Regulation No. 117 (Tyre rolling noise and wet grip adhesion and/or rolling resistance)**Proposal for Supplement 3 to the 02 series of amendments to Regulation No. 117 (Tyre rolling noise and wet grip and/or rolling resistance)****Submitted by the expert of the Netherlands¹**

This proposal was prepared by the expert from the Netherlands, updating the requirements on the noise test track to the latest stage of the applicable ISO standards: from ISO 10844:1994 to ISO 10844:2011. The proposal also incorporates draft transitional provisions to allow repaving of existing, non-complying test tracks with these ISO standards. The proposal contains two alternatives for consideration by the Working Party on Noise (GRB), one referring to ISO standard 10844:2011 and the other reproducing the whole text of the standard. The modifications to the text of the UN Regulation are marked in bold for new or strikethrough for deleted characters.

Figure 1

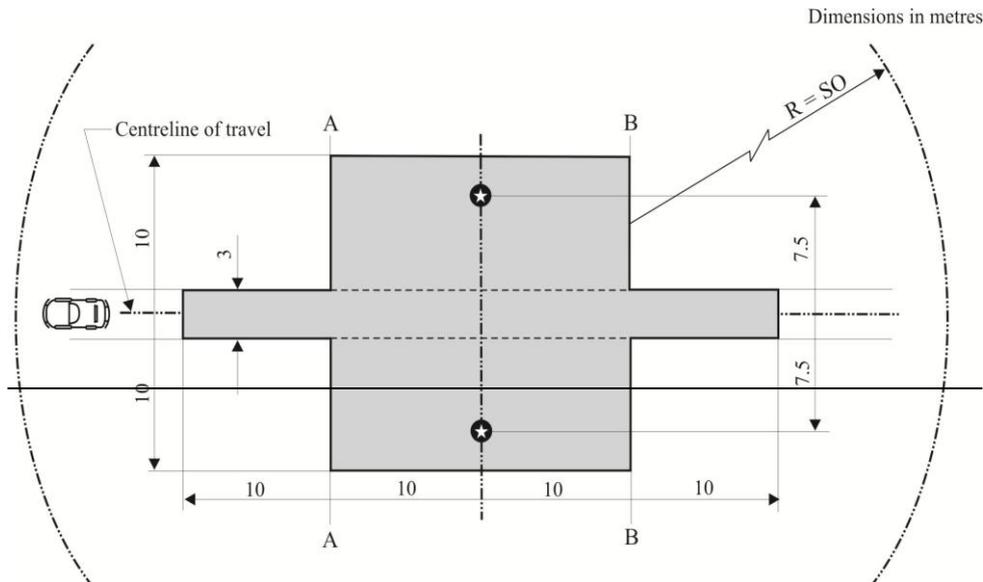
When designing the test track layout it is important to ensure that, as a minimum requirement, the area traversed by the vehicles running through the test strip is covered with the specified test material with suitable margins for safe and practical driving. This will require that the width of the track is at least 3 m and the length of the track extends beyond lines AA and BB by at least 10 m at either end. Figure 1 shows a plan of a suitable test site and indicates the minimum area which shall be machine laid and machine compacted with the specified test surface material. According to Annex 3, paragraph 3.2., measurements have to be made on each side of the vehicle. This can be made either by measuring with two microphone locations (one on each side of the track) and driving in one direction, or measuring with a microphone only on one side of the track but driving the vehicle in two directions. If the latter method is used, then there are no surface requirements on that side of the track where there is no microphone.

Minimum requirements for test surface area. The shaded part is called "Test Area"

Figure 2
Grading curve of the aggregate in the asphaltic mix with tolerances

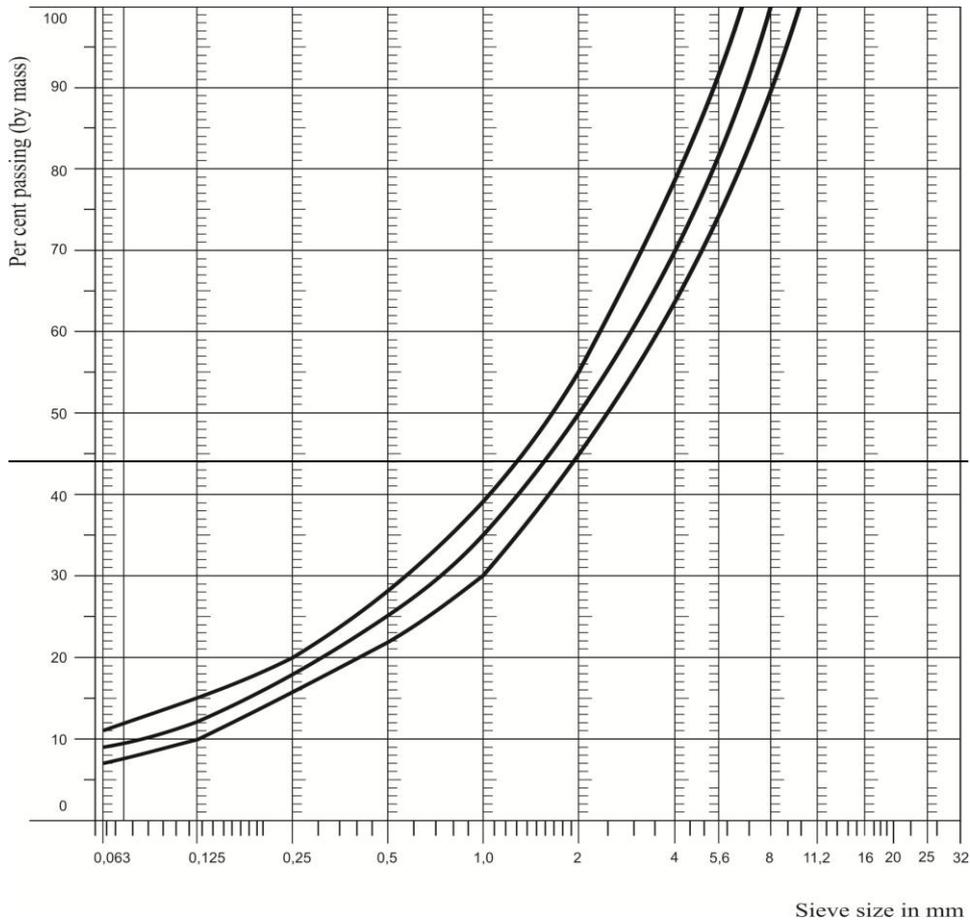
~~As a guide to the surface constructor, an aggregate grading curve which will give desired characteristics is shown in Figure 2. In addition, Table 1 gives some guidelines in order to obtain the desired texture and durability. The grading curve fits the following formula:~~

Figure 1
Size of the test track

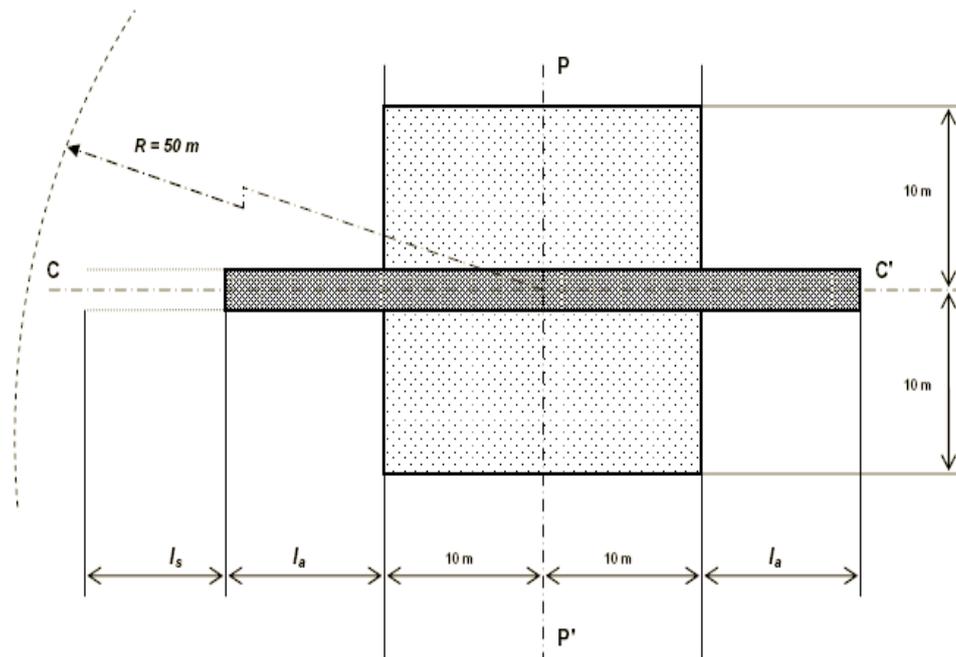
- 3.1.1. Size**
The test track shall consist of two areas, a drive lane and a propagation area. The dimensions shall comply with Figure 1 and Table 1.

A drive lane with a length of l_a and width of at least 3.0 m that is centered around line PP'. The value of l_a is defined in Table 1.

The propagation area shall extend at least 10 m from the centre of the drive lane and at least 10 m at both sides of the line PP'.

Figure 2
Propagation area slope in transverse direction

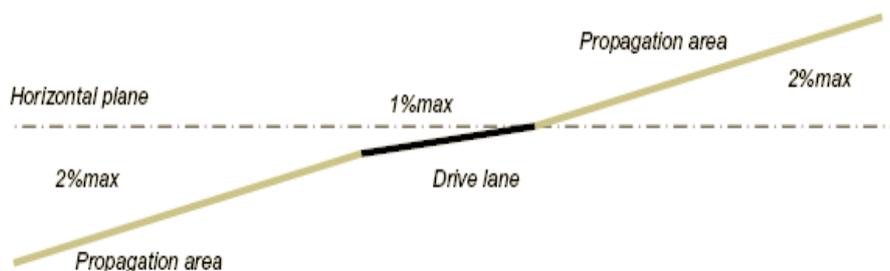
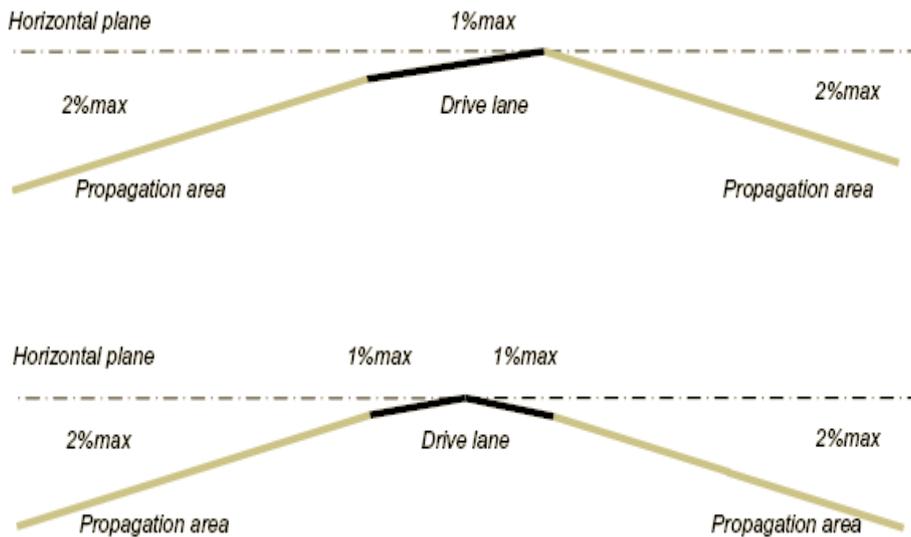
- (i) For acceptance of the test track only, transverse irregularities equal to or less than 0.003 m and longitudinal irregularities equal to or less than 0.002 m measured with the straightedge according to EN 13036-7;
- (ii) For periodical checking of the test track only, transverse irregularities equal to or less than 0.005 m and longitudinal irregularities equal to or less than 0.005 m measured with the straightedge according to EN 13036-7;
- (iii) For acceptance only, deviation from the horizontal plane in transverse direction of 1.0 per cent maximum (see Figure 2) and in a longitudinal direction of 0.5 per cent maximum.

- (i) The propagation area shall have irregularities equal to or less than 0.02 m measured with the straightedge according to EN 13036-7;
- (ii) The propagation area may have one or both sides lower than the drive lane. Cross fall in transverse direction, measured using an appropriate instrument, shall be equal or less than 2.0 per cent (see Figure 2);

Figure 3

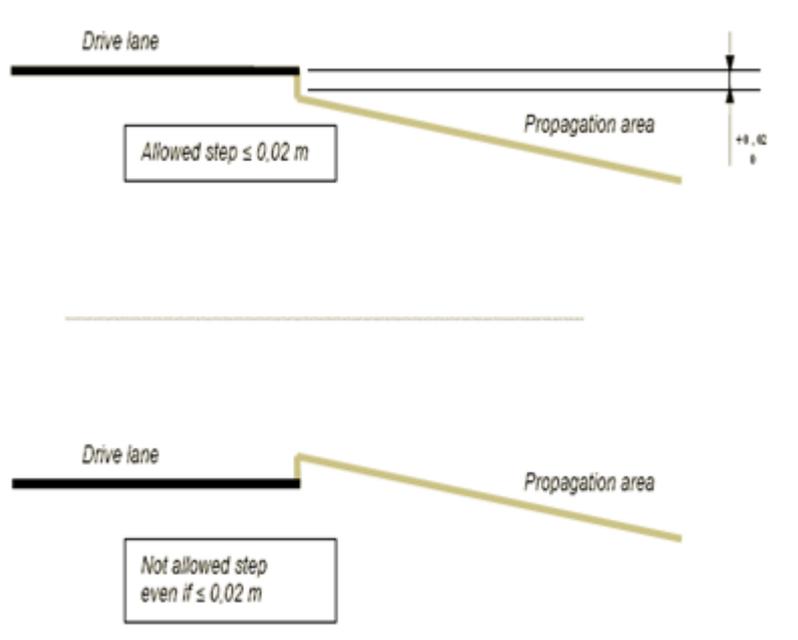
Steps or discontinuities between the propagation area and the drive lane shall be between 0 and +0.02 m. Negative steps are not allowed (see Figure 3).

Figure 4
Sieving curve area

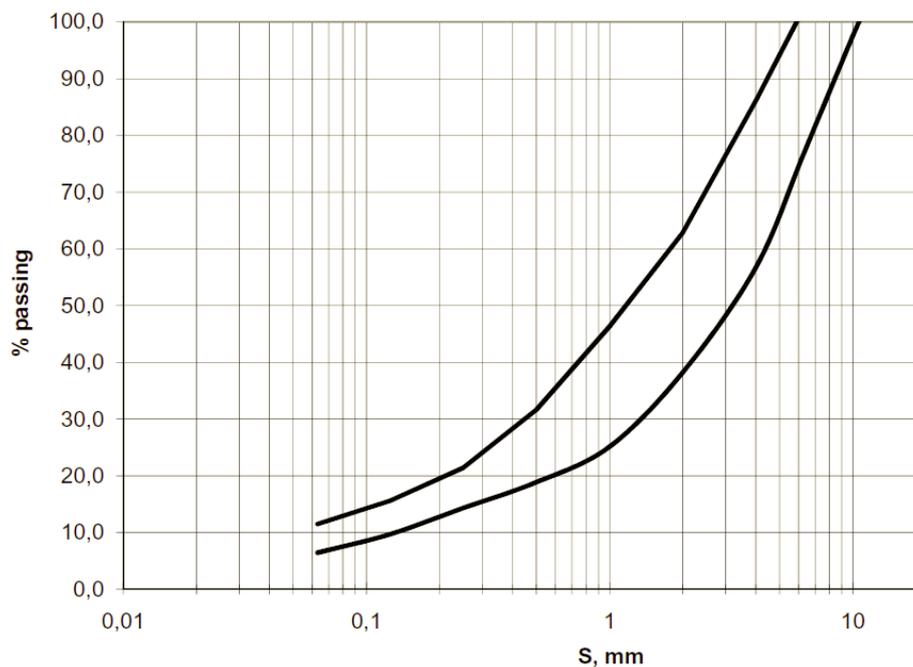
- (a) be of dense asphalt concrete;
- (b) exhibit a sound absorption equal to or less than 8 per cent in any one-third-octave band between 315 Hz and 1 600 Hz when measured according to 4.3;
- (c) have a maximum chipping size of 8 mm (tolerance allowed between 6.3 mm to 10 mm);
- (d) have a thickness of the wearing course greater than or equal to 30 mm;
- (e) have a Mean Profile Depth measured according to ISO 13473-1 of $0.5 \text{ mm} \pm 0.2 \text{ mm}$;
- (f) have a target sieving curve for the aggregate as shown in Figure 4.

Figure 5
Measurement positions on test track, example for $l = 40$ m

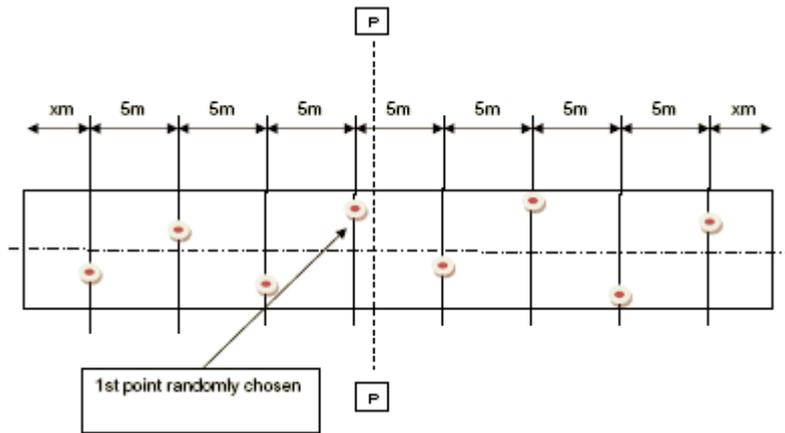
- (b) During the periodical checking of the track (refer to Table 2);
- (c) All measurements shall be made along the total length of the drive lane in each wheel track according to the following scheme to Figure 5;
- (d) For sound absorption, texture, geometrical compliance, the first test point shall be chosen randomly on each side in the vicinity of the line PP' and the subsequent measurements shall be performed at 5 m intervals not on the same axis of the centre line to cover the whole track;
